JOE SEVARIO ROAD AT MERRITT EVANS ROAD AND NORWOOD ROAD

PARISH PROJECT MA-18-13

ADDENDUM NO. 1

DATE ISSUED: MAY 4, 2021

TYPICAL FINISHED SECTION (N.T.S.)
 APPLIES TO
 NORWOOD RD STA 400+0.00 TO 400+66.67
 MERRITT EVANS RD STA 500+96.95 TO 50+47.64
 DEVALL RD STA 50+67.64 TO 502+8.74

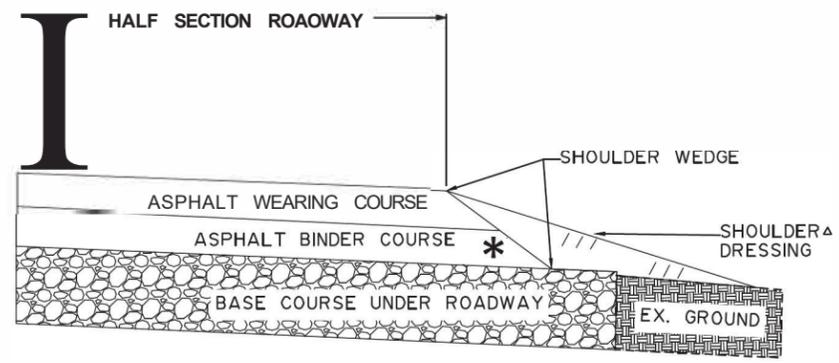
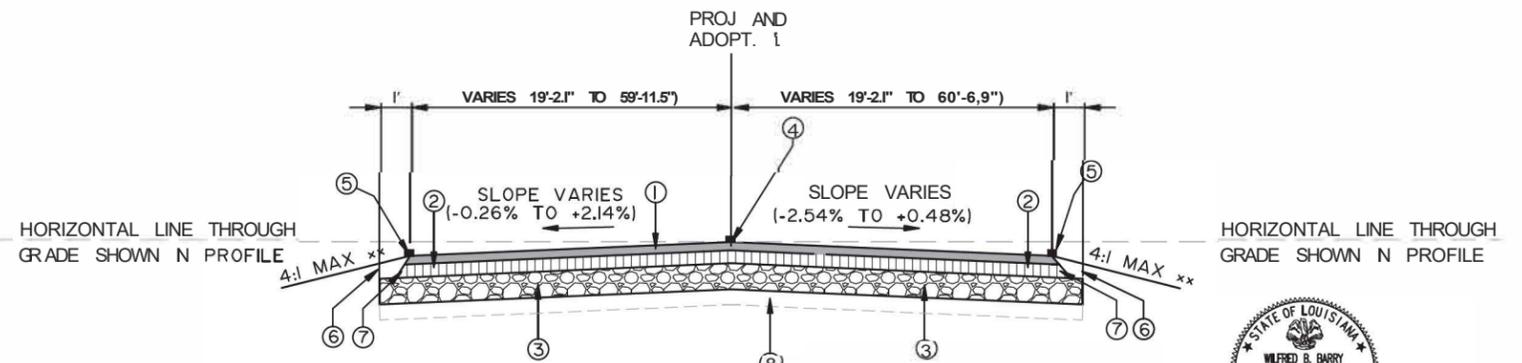
4. Q: How are the Alternate Class II Base Course bid items to be handled?
A: The Class II Base Course (Soil Cement) option has been removed as an option for this project. The ONLY Class II Base Course option for this project is "Bid Item 302-2-12070 CLASS II BASE COURSE (12" THICK) (CRUSHED STONE OR RECYCLED PORTLAND CEMENT CONCRETE)". New Bid forms and Typical section are attached and made part of this Addenda. This Pay item is to be included in the Base Bid on Sheet # D105.

- 1) 2" ASPHALT CONCRETE WEARING COURSE (LEVEL I)
- 2) 3" ASPHALT CONCRETE BINDER COURSE (LEVEL II)
- 3) ~~12" CLASS I BASE COURSE (SOIL CEMENT 8% BY VOLUME; AN ACTUAL DETERMINATION SHOULD BE MADE USING LA DOTD TR 432-02)~~
- OR
- 3) 12" CLASS I BASE COURSE (CRUSHED STONE OR RECYCLED PORTLAND CEMENT CONCRETE)
- 4) PAVEMENT STRIPING & REFLECTORIZED MARKERS
- 5) PAVEMENT STRIPING
- 6) EMBANKMENT
- 7) SHOULDER WEDGE (SEE DETAIL THIS SHEET!)
- 8) 12' COMPACTED USABLE SOILS (TYPE E LIME TREATMENT (9% BY VOLUME) (LOCATIONS TO BE DETERMINED BY PROJECT ENGINEER!)

SHEET NUMBER	
PARISH	
CONTROL SECTION	
STATE PROJECT	
DESIGNED	
CHECKED	
DETAILED	
CHECKED	
SERIES NUMBER	
BY	
REVISION OR CHANGE ORDER DESCRIPTION	
DATE	
NO.	
TREE AND SHRUB PLANTING DETAILS LD-01

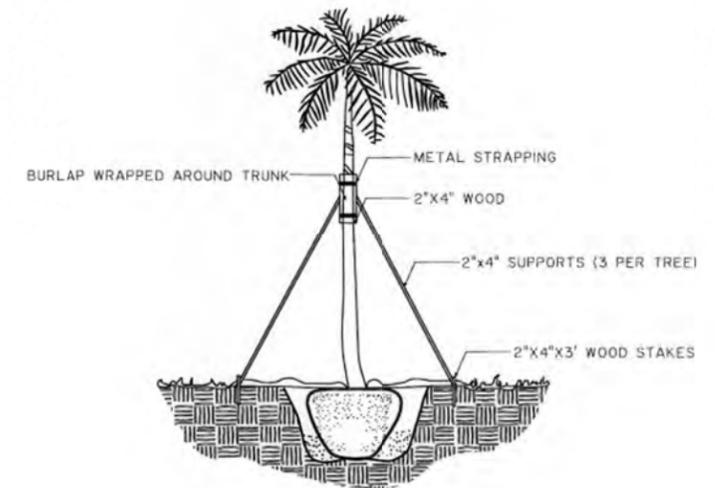
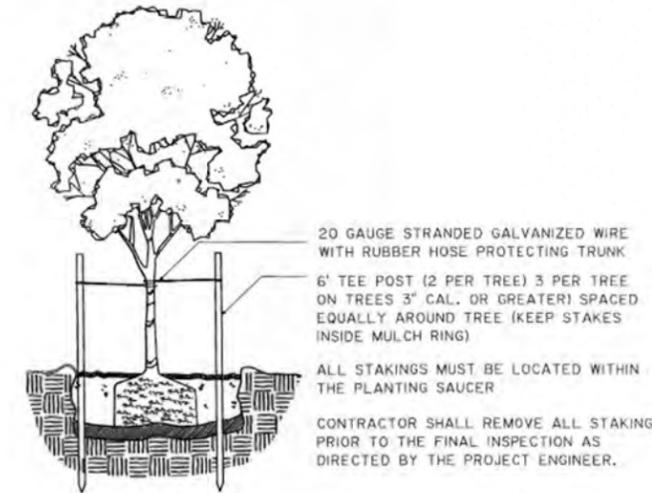
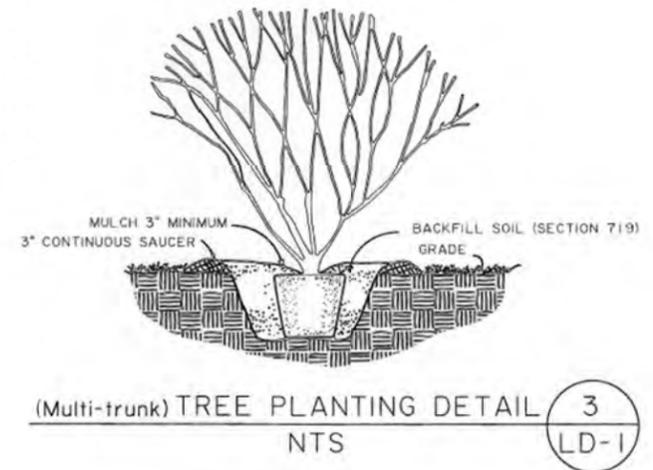
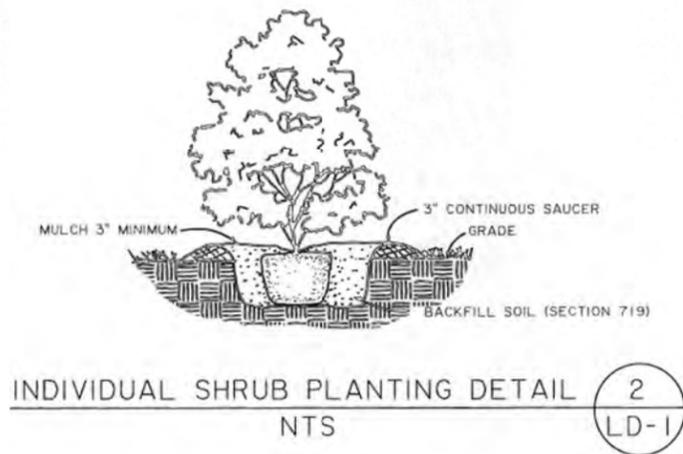
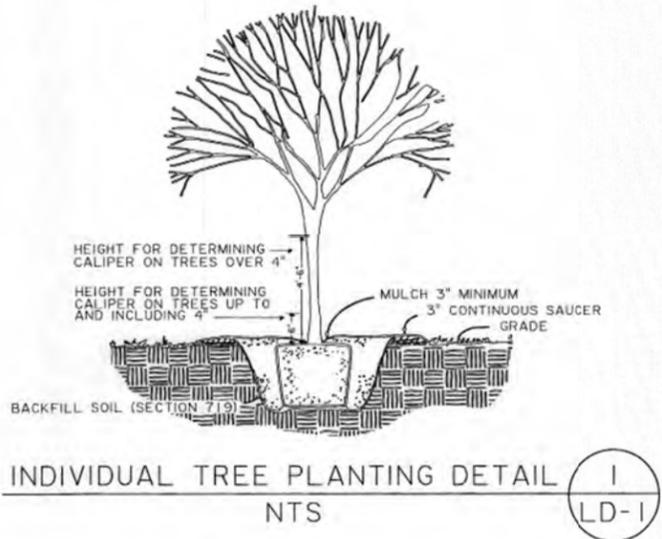
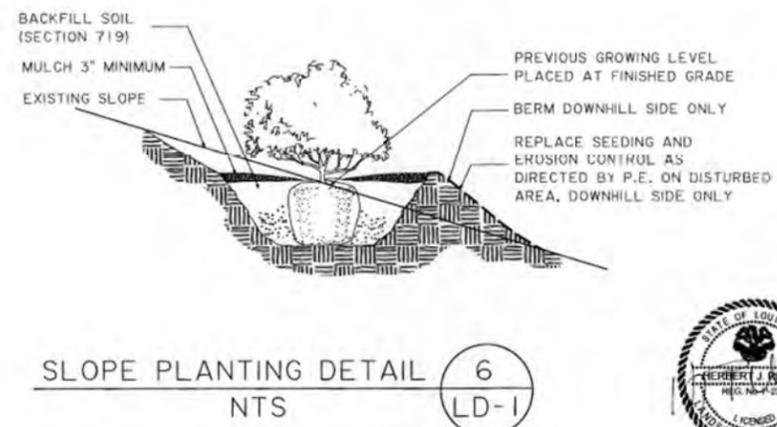
2. Q: If the tree is off of the right-of-way but the limbs are extending over the right-of-way, how high should the limbs be trimmed?
A: Tree pruning will be conducted per DOTD Standard plan LD-01 (added per this Addendum, see attachment), as well as Section 201.04 of the 2016 Louisiana Standard Specifications for Roads and Bridges Book (Purple Book).

3. Q: Standard plans LD-01 and LD-02 are missing from the plan set. Can they be provided?
A: LA DOTD Standard plans LD-01 and LD-02 are provided as part of this Addenda.
